ARCHITECTURAL ACCESS BOARD- HEARING PACKET

Name	Salem YMCA	Docket #	V 25 - 089		
Address	1 Sewall Street	Docket #	C -		
City	Salem	Hearing	8/24/2026		
Bldg Type		Time of hearing	11:00 AM		
Complaint's Name		Plans on file?			
Complaint ?	Variance ?	Request for continuance?			
Jurisdiction:	3.3.2	If the work performed amounts to 30% or more of the full and fair cash value of the building, the entire building is required to comply with 521 CMR.			
Building Permits:	Anticipated construction cost: \$3,500,000				
Assessed Value:	\$4,226,800

Exhibit: 1
V25-089
AAB 1-117

Petitioner seeks relief from: 26.6: A minimum clear floor area shall be provided on both sides of all doors and gates.

DEMOLISH EXISTING
BRICK WALL TO CEILING
LEVEL AND INSTALL A
STEEL HEADER.

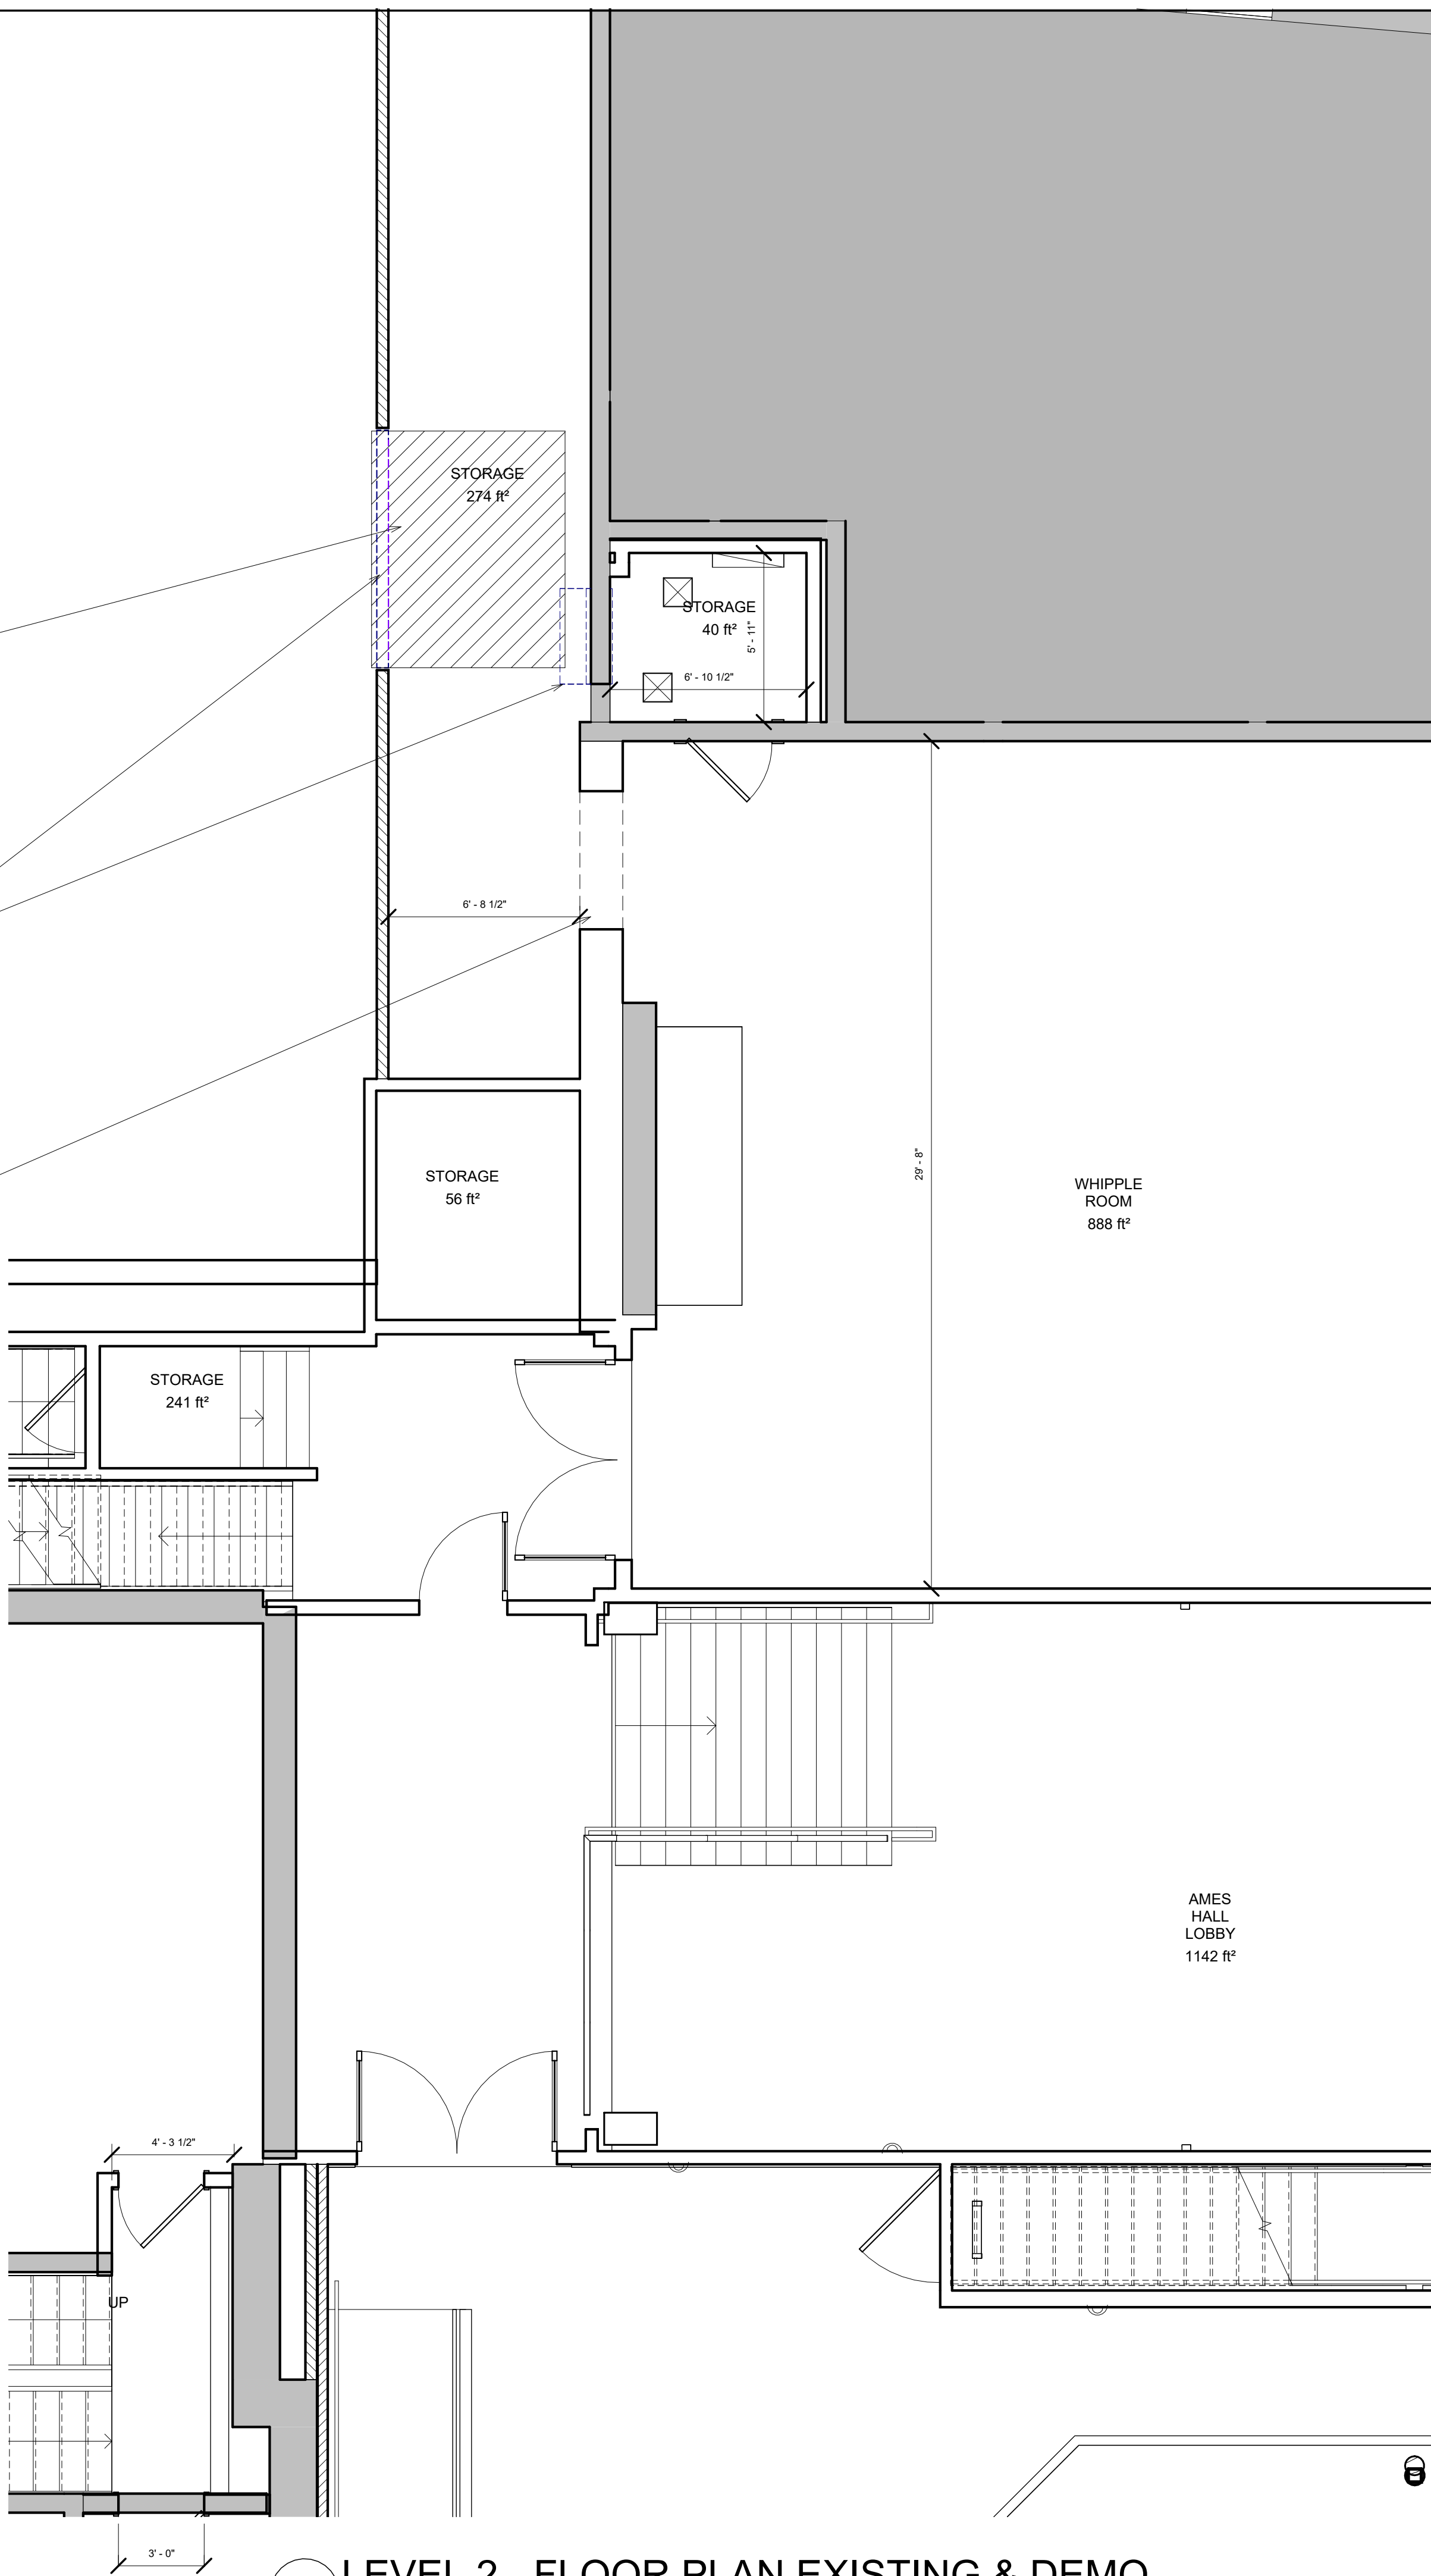
- to **CONTINUE** Petitioner's Request 1 for relief from 521 CMR 20.1 (entrance) and 28.1 (elevator) and **ORDERS** Petitioner to provide the Board with: (1) test drawings for a permanent or portable lift to the basketball court; and, (2) the policy on relocating on request special programming in the basement;

1. See Attachment C for test drawings to provide an accessible route to the flex gym space. Note that the scope of work includes (1) adding another stop to the elevator and opening the existing shaft wall and (2) construction of a new ramp to access the space.
2. See Attachment A for the written policy for relocating the special programming throughout the facility.

1 LEVEL 2 - FLOOR PLAN NEW
SCALE 1/4" = 1'-0"

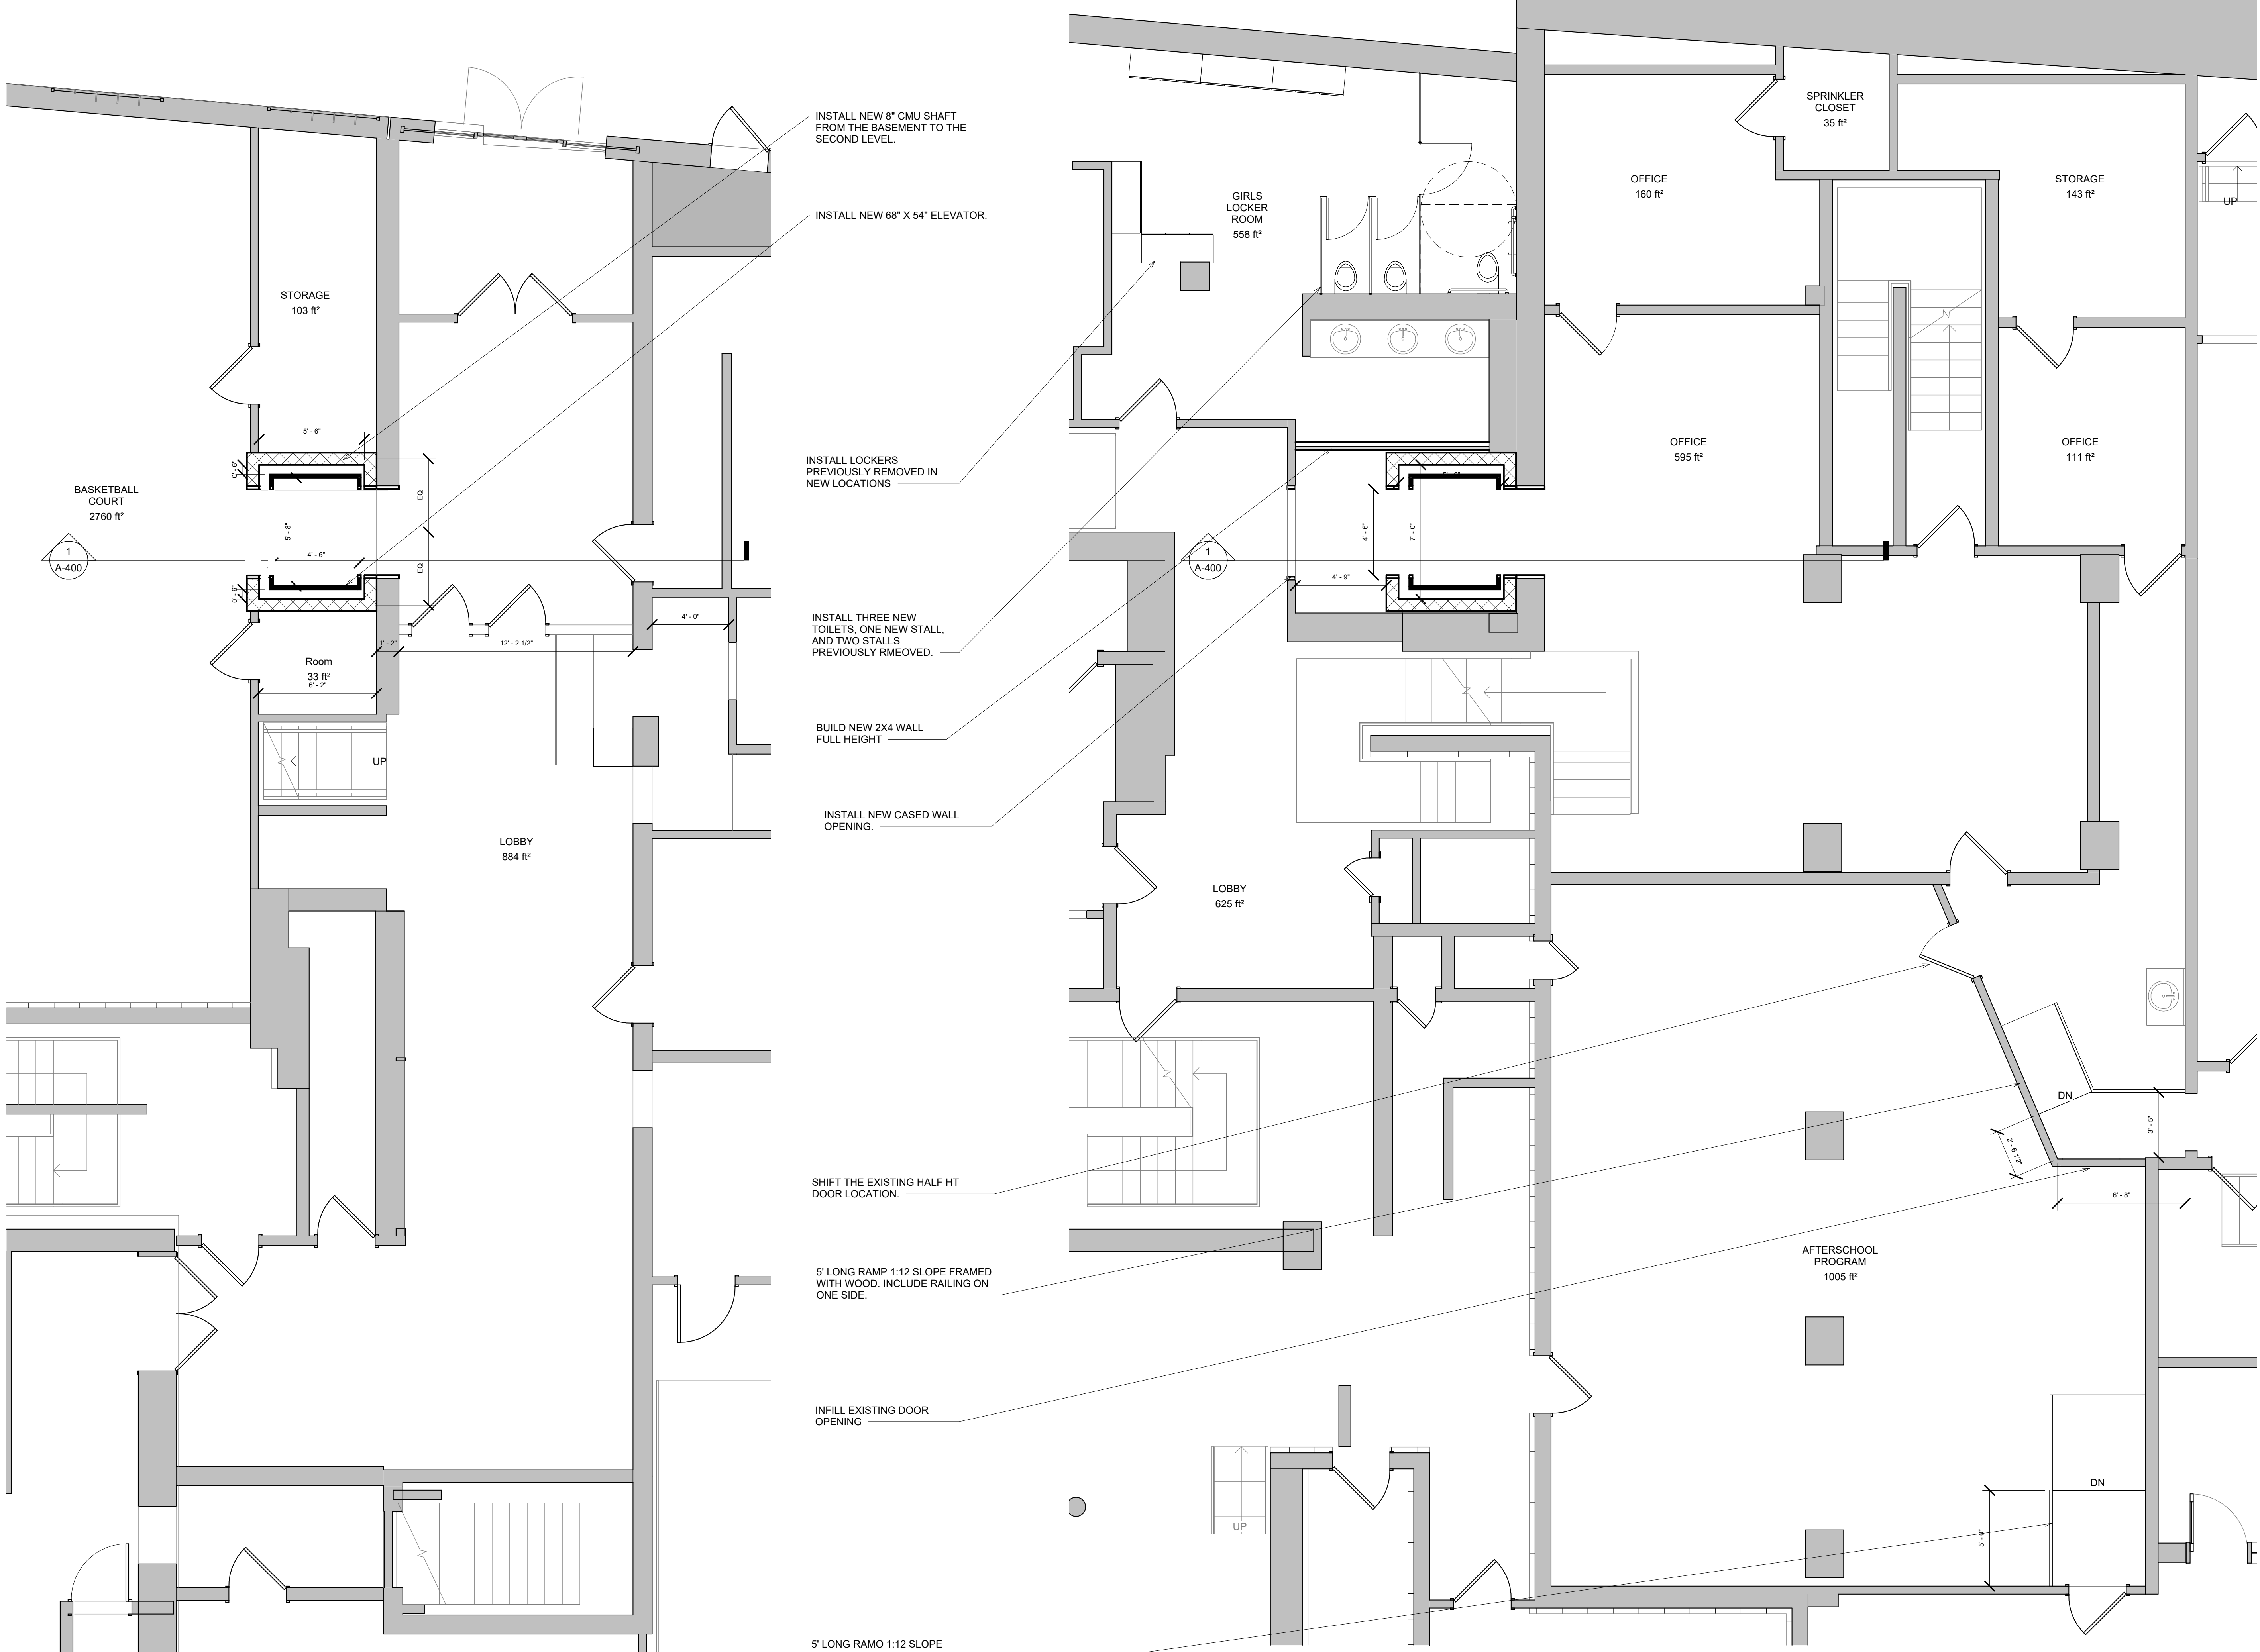
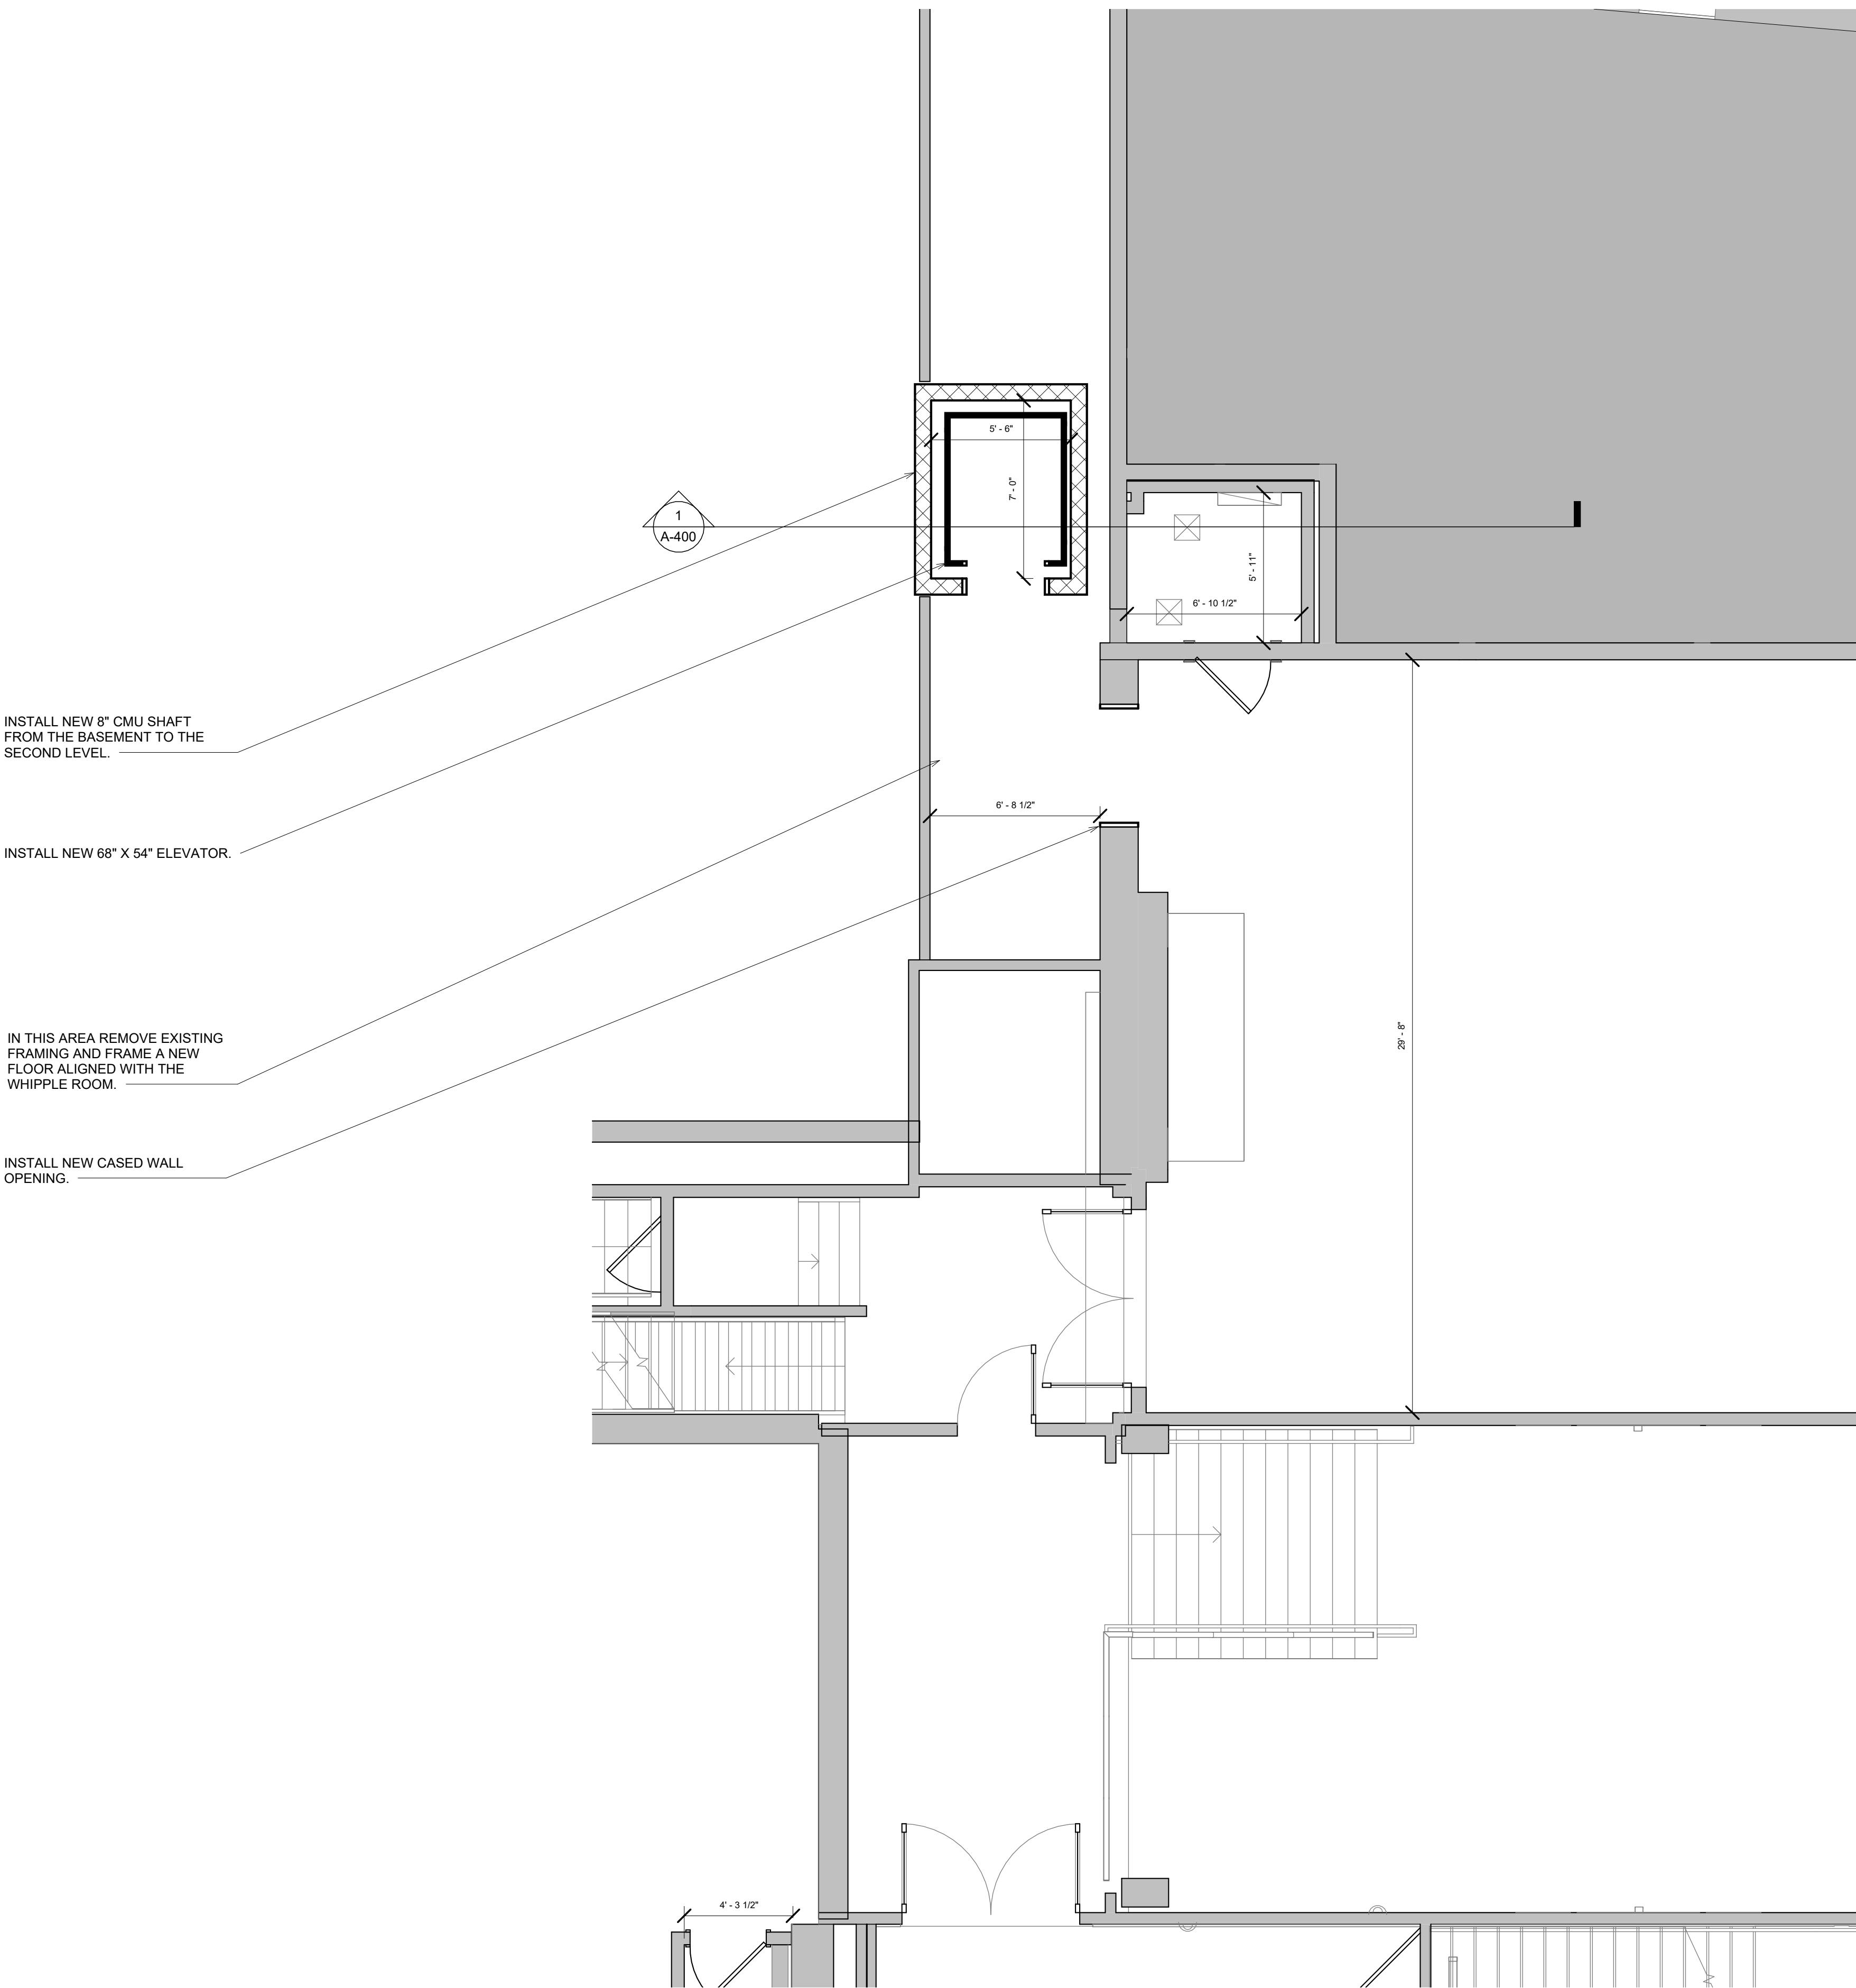
1. Plan identifying doors and spaces impacted by this request.

1. See Attachment E for updated floor plans. The first sheet identifies the existing conditions and the second identifies the proposed remediation / doors that are proposed to remain inaccessible. The table below summarizes the number of compliant and noncompliant doors before and after the proposed remediation:
